Final Reviews on HARB-Approved Projects:

**Allentown Historical Architectural Review Board
FINAL Review Sheet**

HDC-2023-00099

Address: 112 N. 11th Street

**Side facade with chimney at 1142 Emmett Street
(applicant)**

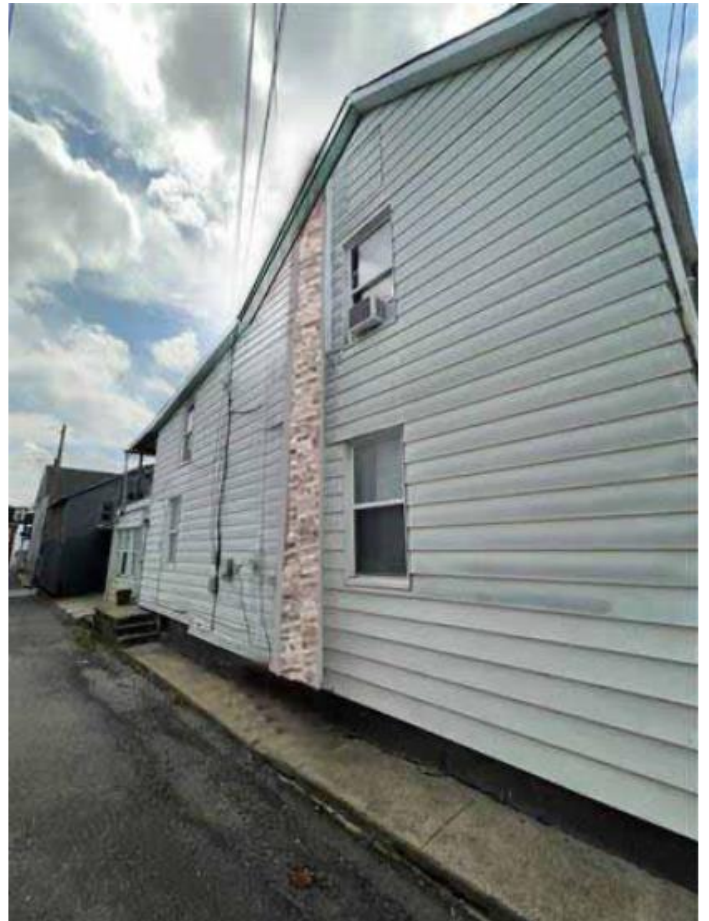
Observations & Comments: The chimney proposed to be removed is not original to the building. It was pulling away from the building at the top and is currently partially removed. Its removal should not be an issue since it was not original to the house and because it encroaches on the public sidewalk. The question is how to infill the gap in the siding when removed. The applicant's proposal to infill with stone is not historically appropriate. It may be appropriate to infill with brick instead or to cover the area with new siding that ties into the siding on one of its sides.

Staff Recommendation: It is recommended to approve either infilling the area with brick or infill the area with new siding that ties into the siding on one of its sides.

**240 1/2 Hall St Front
(applicant)**

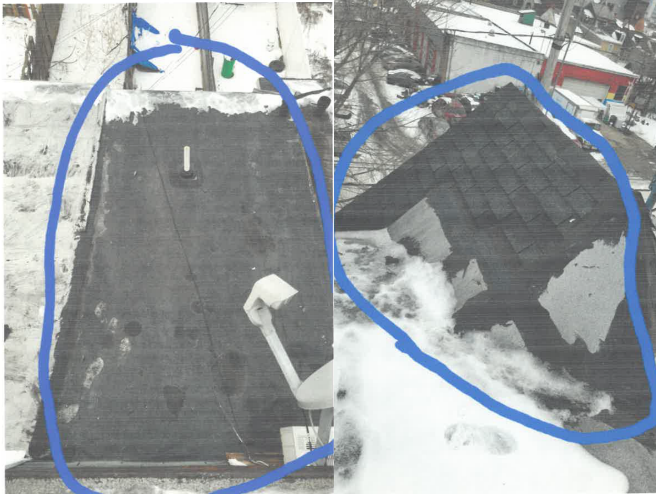
Observations & Comments: The upper flat roof areas proposed to be replaced with rubber membrane roofing are not visible from the public ROW, however the edge metal will be visible. The upper edge of the Mansard is currently covered with loose aluminum flashing. It is not known if the historic wood molding (seen on the neighboring property) is still extant. The aluminum flashing piece should be removed and the molding repaired or replaced in-kind and painted. The membrane roof edge should match the trim color (white)

The replacement of the existing 3 tab asphalt/fiberglass shingles on the Mansard and one side of the dormer gable is historically appropriate if the shingles are 3 tab shingles to match existing in style and color or GAF Slateline shingles in the Antique Slate color or equivalent. The proposed architectural shingle does not recall slate and is not supported by the Design Guidelines. The replacement of flat seamed metal roofing on the front and rear porches is also proposed. The surface of the front porch roof is hard to see from the street, the rear roof is visible from Emmett St. which is a short narrow alley. The proposal to replace the metal roofing with shingle is not historically ideal but other nearby or adjacent roofs have been replaced with asphalt shingles. Because of the lack of visibility of the front roof and the low level of visibility of the rear roof, the HARB should consider replacement with 3 tab shingles to match the existing Mansards or with GAF Slateline shingles.

The built-in gutter at the third floor needs to be repaired in kind and the box gutter relined to extend its use. The K gutter at the front porch is shared with the neighbor. It should be repaired and replaced in kind or replaced with a more historic half-round gutter. Adequate hangers must be used to deter failure.

Action: Mr. AJ Jordan moved to approve, with conditions, the application presented on March 4th, 2024, replacement of roofing at 204.5 Hall Street, pursuant to Chapter 3, Section 3. Chapter 3.1 – Roofs. The following conditions were agreed to by the applicant:

- The roof shingle will be GAF Slateline shingle in Antique Slate color or equivalent
- No gutter work will be done without review unless it is done in-kind.
- The porches will also be reroofed with the same GAF Slateline shingle.
-

**1021 Linden St after fire damage May 2023
(applicant)**

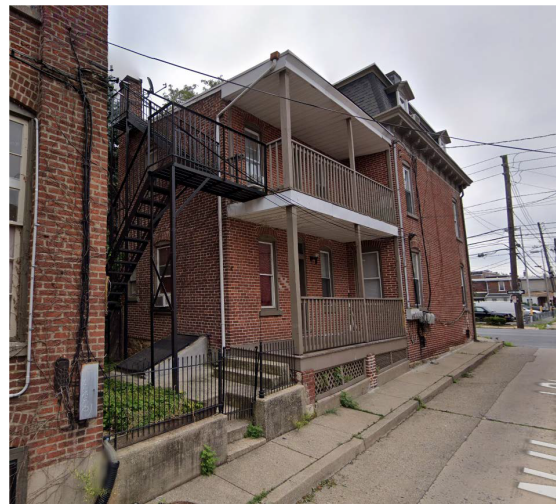
Observations & Comments: The reconstruction of the second floor of the existing porch is historically appropriate in concept. The treatment of the wood fascias, and spec for the vented soffit should be discussed or supplied. It would be an historic improvement if vented beaded soffit material was used. The pressure treated floor decking and balusters must be painted when appropriately dried. Eastlake style railings included both straight and turned, historically. The proposed turned balusters would be historically appropriate if painted. Since the former windows were vinyl, replacement with vinyl is supported by the Design Guidelines. The new door should match the existing as proposed.

Discussion: The discussion focused mostly on the historic consultant suggestion to utilize a vented beaded soffit material. Other aspects of the work were agreed were historically appropriate and met the Historic District Design Guidelines. Mr. Huber suggested an alternate to soffit that matched the existing (vented aluminum or vinyl material). He said the roof could be redone with tongue and groove beaded board sheathing and exposed rafters. That would eliminate the ceiling and venting issue.

The vented beaded board material was further discussed and described. Although a vinyl product the historic consultant said it was a close replica of painted beaded board. The HARB generally expressed support for this material instead of matching the existing which was not historically appropriate.

Mr. Jordan moved to approve, with conditions, the application presented on March 4th, 2024, for porch repairs at 1021 Linden Street, pursuant to Chapter 3, Section 3. Chapter 3.7 – porches and Steps. The following conditions were agreed to by the applicant:

- The work will be undertaken as shown in the architectural drawings submitted to the HARB
- The porch soffits will be changed to be a vented vinyl beaded board material as described at the meeting.
- The alternate option to redo the roof sheathing with wood beaded board and delete the ceiling was also offered.
